### **ITEM FOR ENVIRONMENTAL COMMISSION AGENDA**

**NAME & NUMBER OF PROJECT:** 305 S. Congress Planned Unit Development, C814-89-0003.02

**REQUEST:** To amend the current PUD.

**STAFF RECOMMENDATION:** Current proposal is not considered environmentally superior and thus not recommended but would be with the following conditions.

Options to Avoid Tree Removal

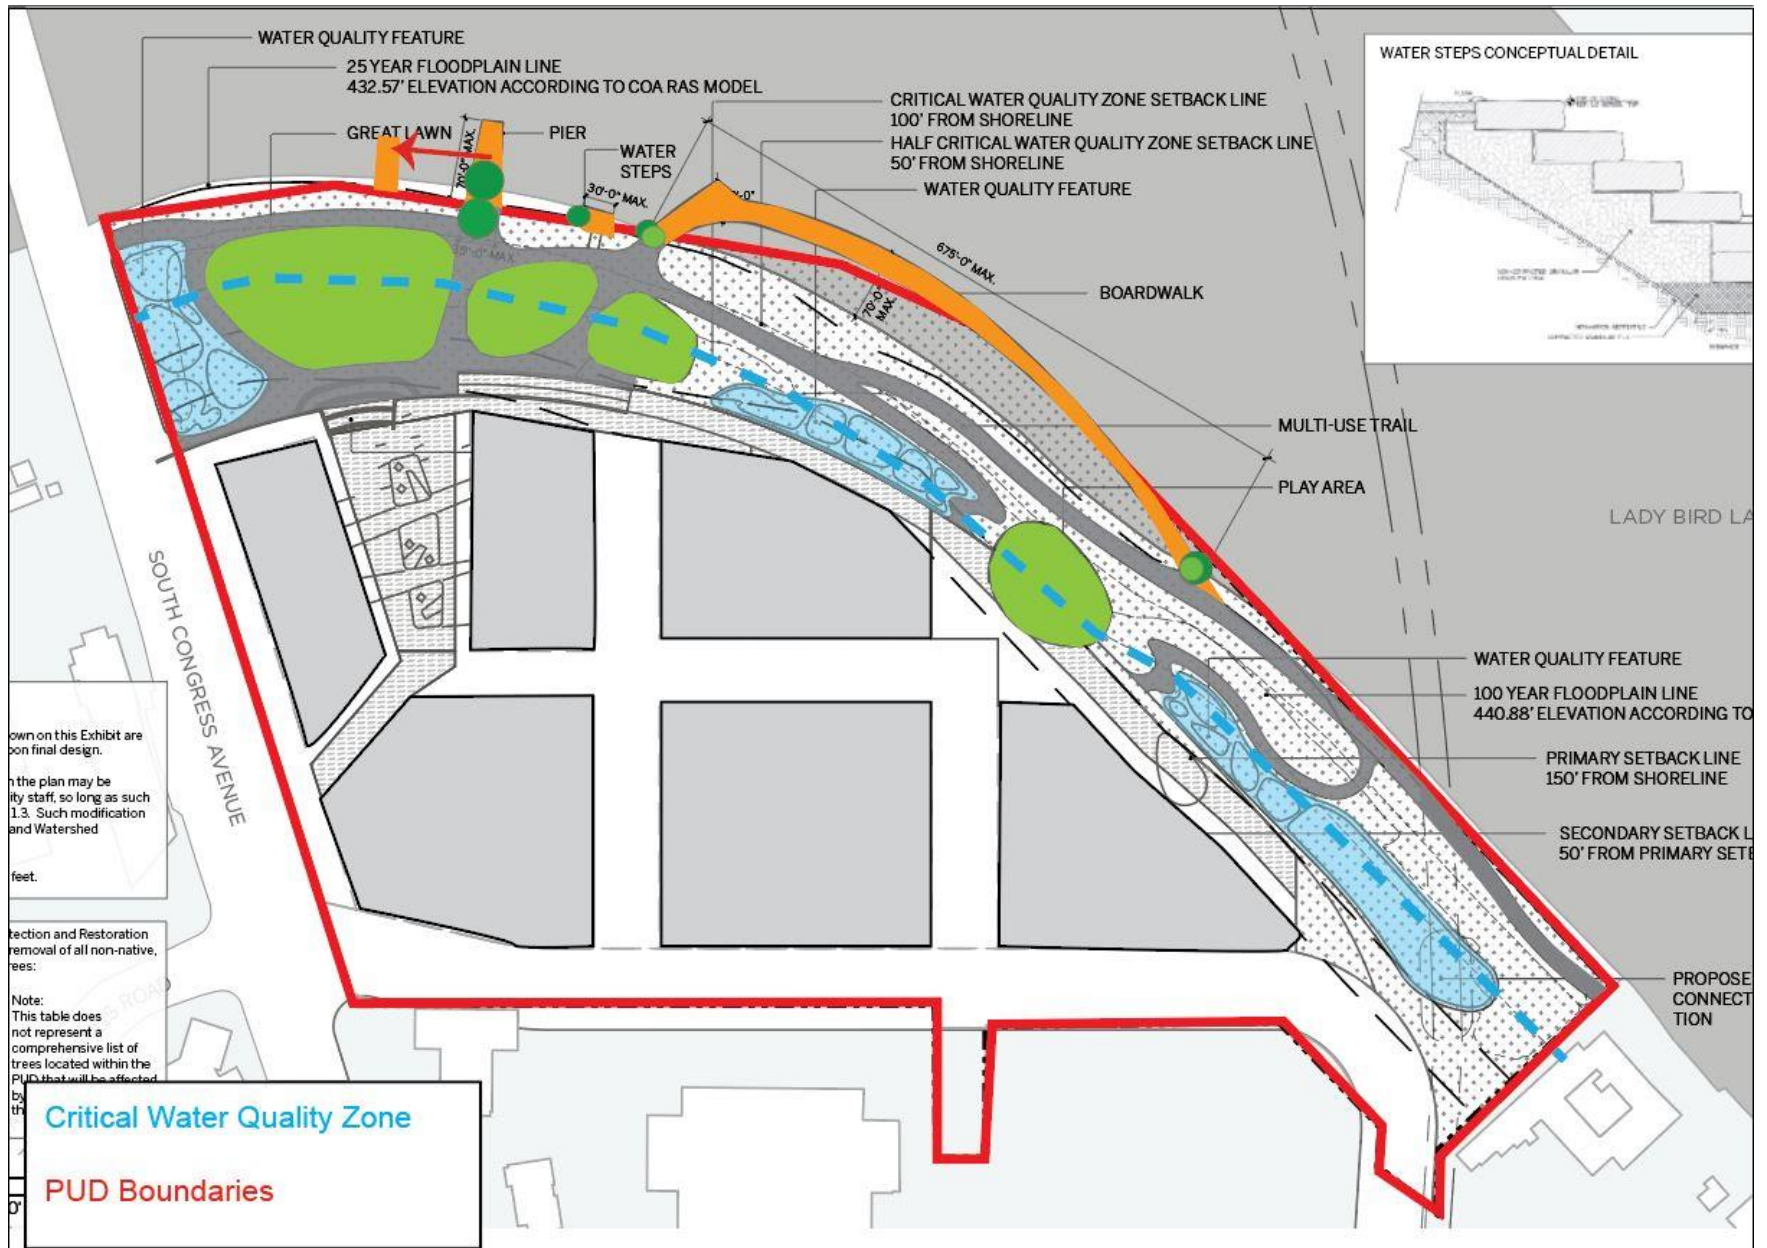
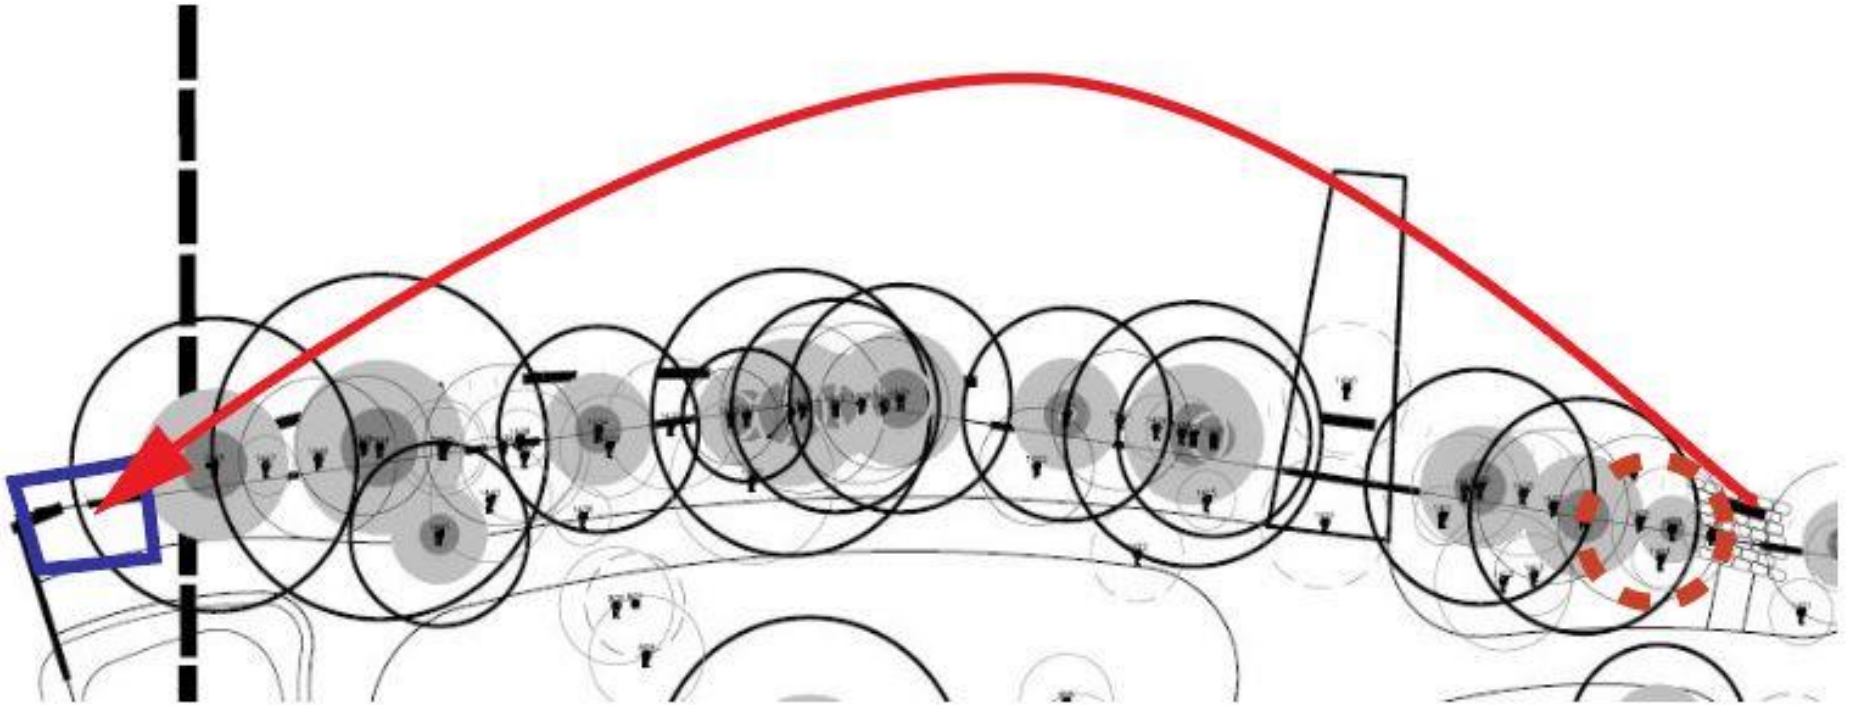
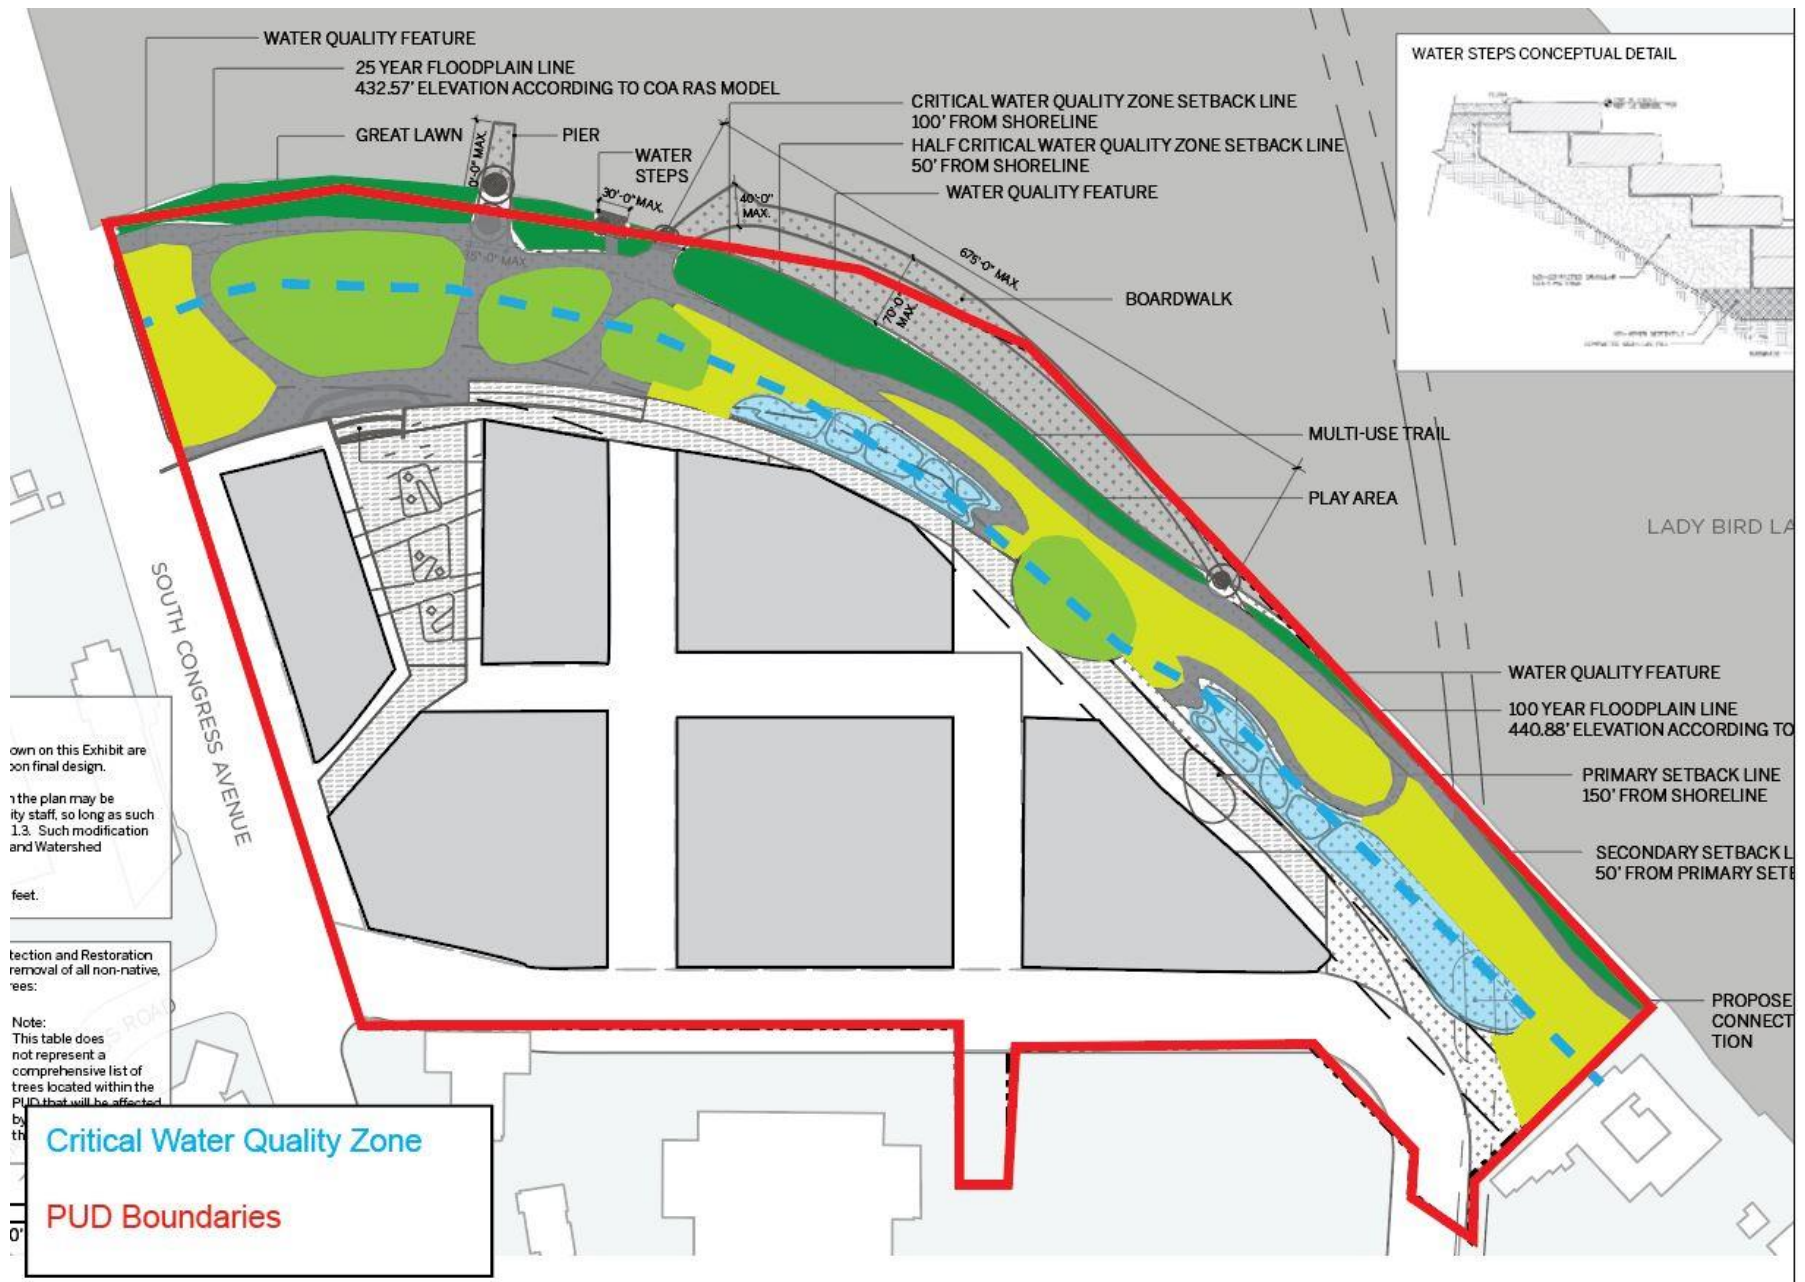
5. Complete a Parkland Improvement Agreement that includes maintenance for the water quality ponds located within the parkland.
6. Move and narrow the proposed pier to a location that does not impact existing trees.

9. Preserve or transplant 100% of all Heritage trees and preserve 77% of tree overall on-site.
10. Provide 1000 cubic feet of soil for street trees, can be shared by a maximum of two trees.

Current Trail Access

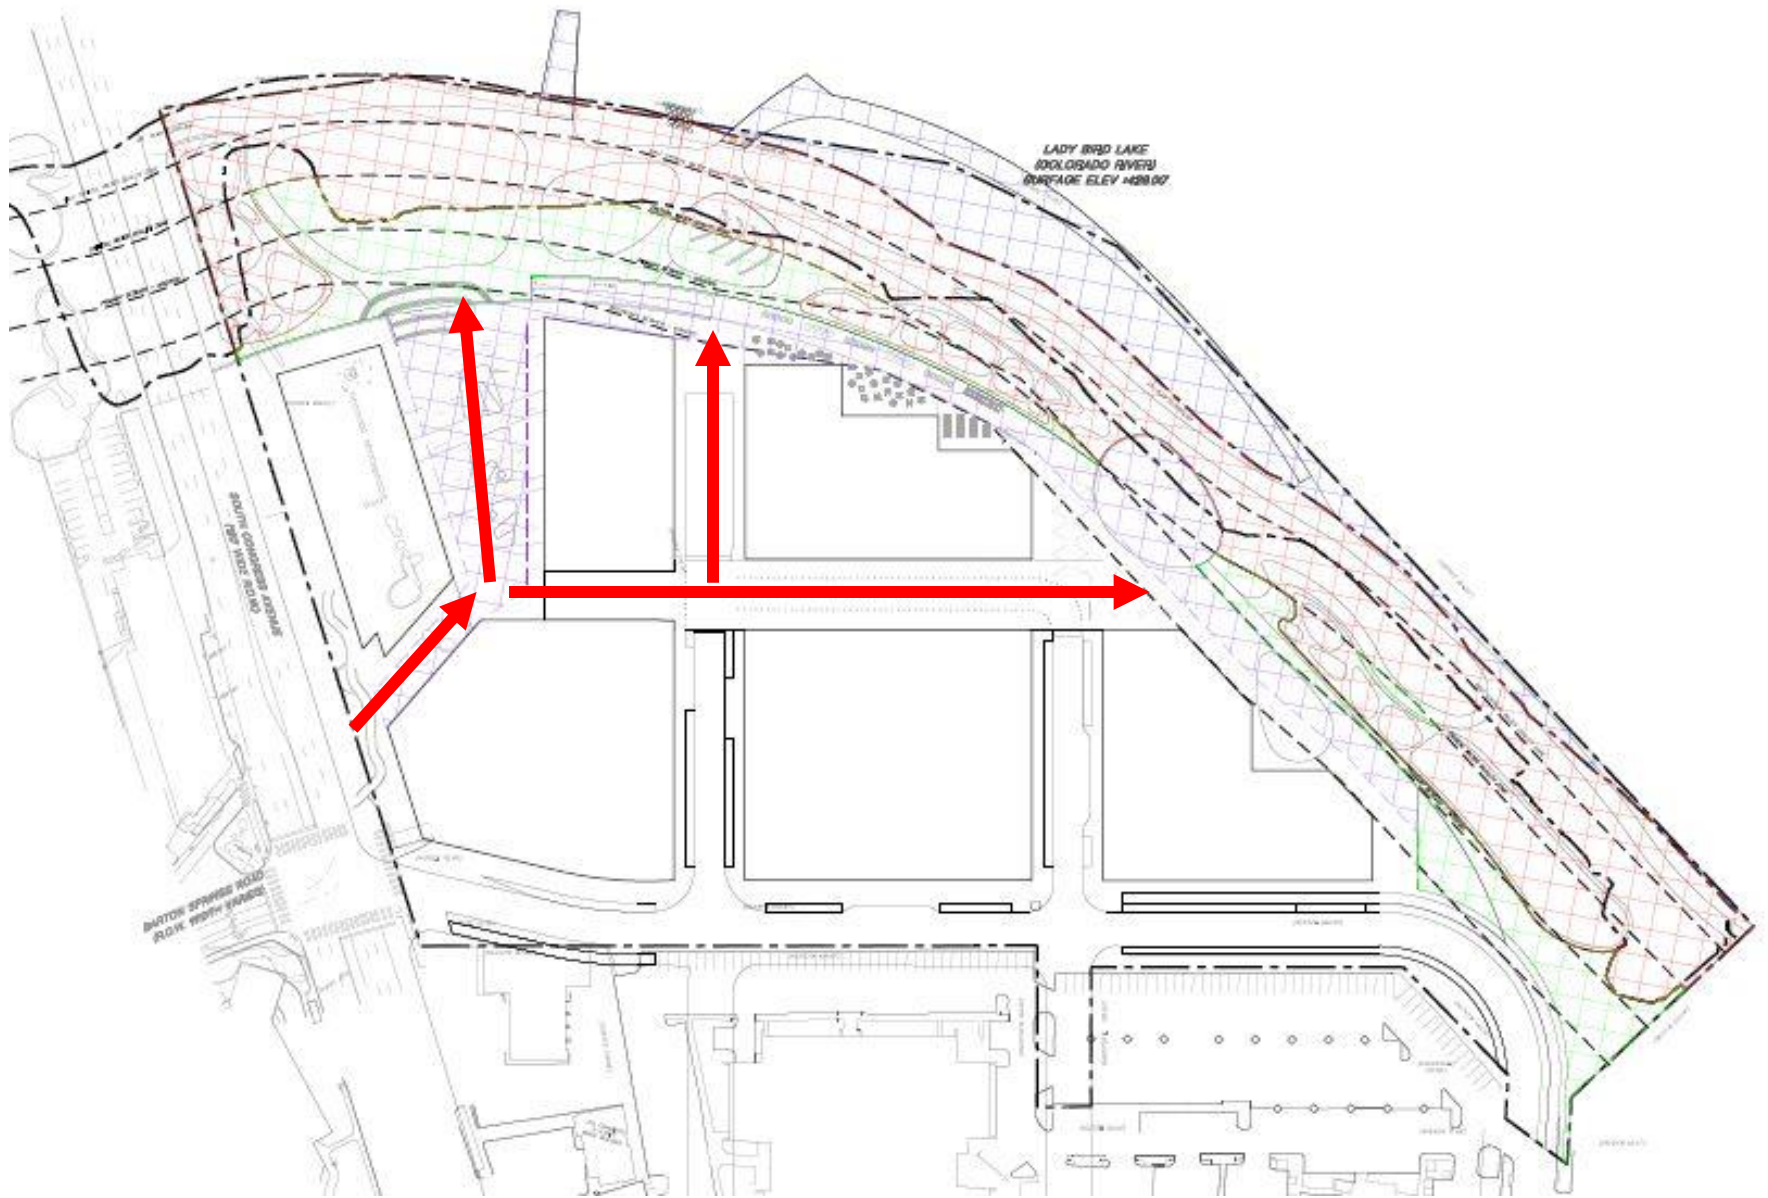
3. Provide public equitable access from S. Congress ROW to the Hike and Bike trail that does not force visitors through the development.
4. Provide \$100 over what is required by current code to build park amenities.
